P2001647 – Brighton and Sussex University NHS Trust
Brighton 3Ts

Doc No: BDP-AR-SW-RP-0143

Title: Extract from D+ Design Report

Project: Brighton 3Ts **Date:** 29 August 2014
Client: BDP **Author:** J Barnfield
Ref: TS14236-N03-ISSUE 1A **Checked by:** S Hibberd
Re: Energy Centre - Fire safety review

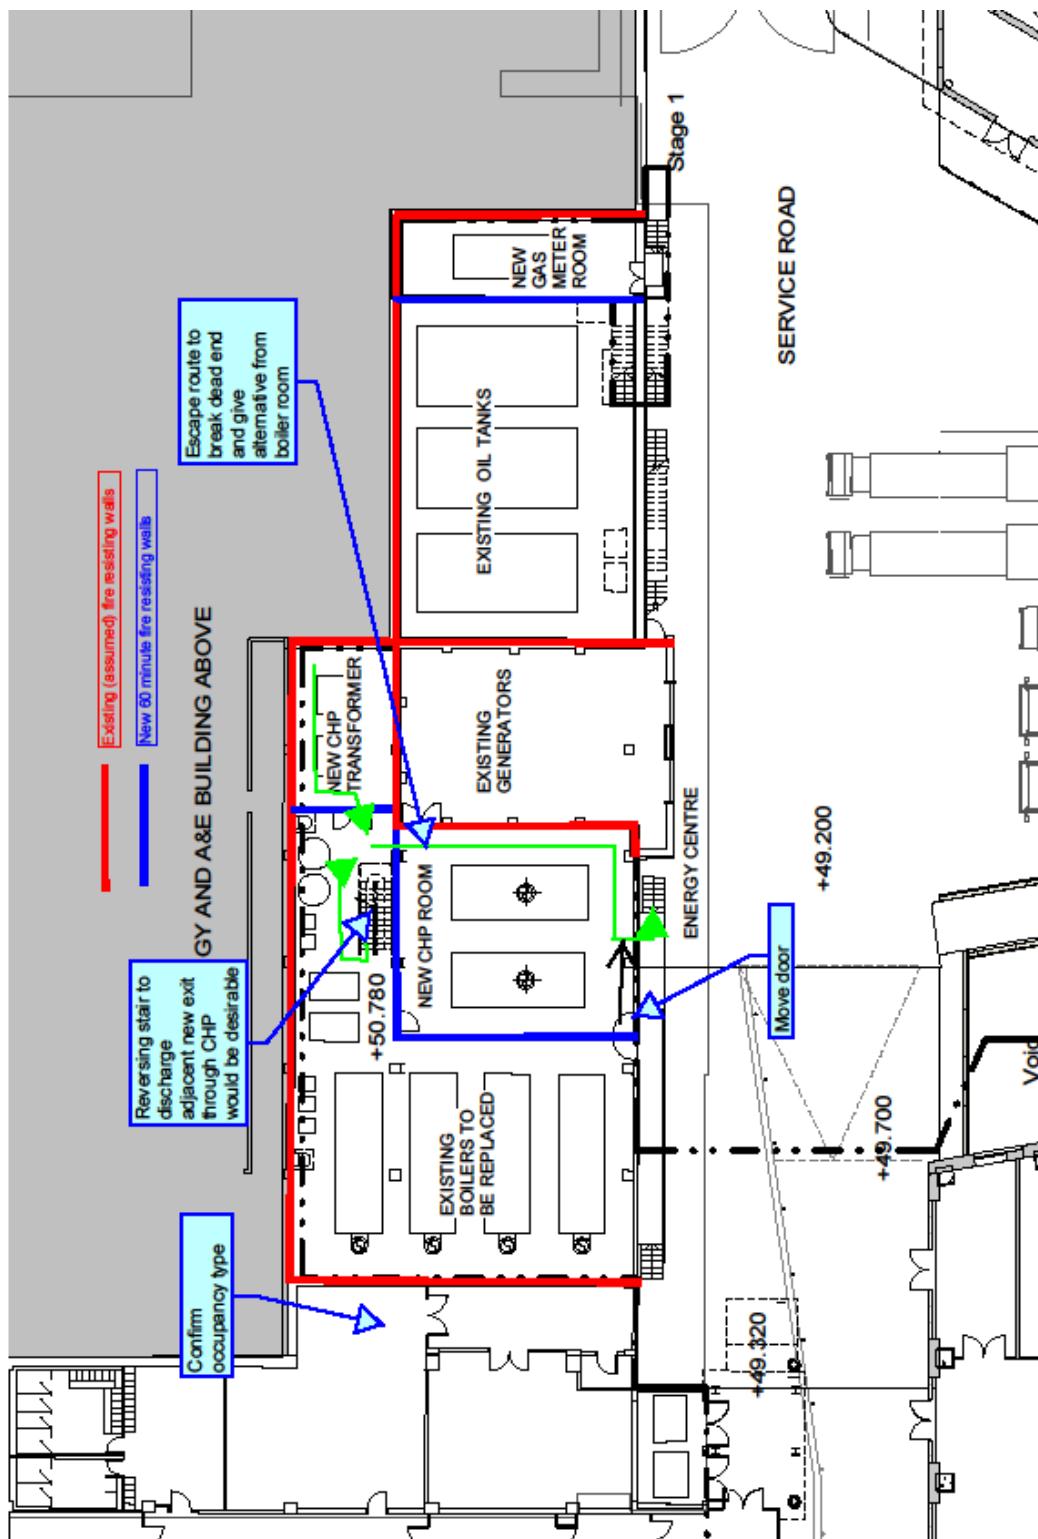
The drawing mark-ups appended to this note indicate the suggested compartmentation and escape route provision to achieve statutory compliance.

Provision	Conflict with guidance	Comments
Means of warning and escape		
The maximum travel distance in a plant-room should not exceed 25 m or 12m in a dead end. (Extended to 35m and 25m for low risk plant e.g. AHUs). Escape routes to be minimum 2m clear height.	Dead end travel distance from CHP transformer room exceeds 12m. Two escape routes are required from the mezzanine.	Provide alternative clear escape route through CHP as indicated on attached sketch. Provide second route off mezzanine as indicated on attached sketch.
Escape stairs should be enclosed in fire resisting construction and discharge to outside.	Open stairs and ladder from boiler room mezzanine do not meet this recommendation.	Travel distances are within guidance and the mezzanine is assumed to have only a low and occasional occupancy. An open stair and ladder is therefore considered acceptable subject to agreement with approvals bodies.

Provision	Conflict with guidance	Comments
Motorised fire and smoke dampers should be provided in all compartment and sub-compartment walls.	It is not known what type of fire dampers are currently installed in fire resisting construction or their current state of maintenance.	Review existing installations and establish whether upgrading of existing dampers and fire stopping etc. is appropriate.
External fire spread		
External walls may need to be fire resisting to prevent fire spread from building to building.	The location of new 3Ts building places a potential restriction on unprotected areas to the external wall of boiler plant room.	The provision of a fire resisting wall (60 min) between boilers and CHP plant as shown on attached sketch should remove any restrictions on external wall.
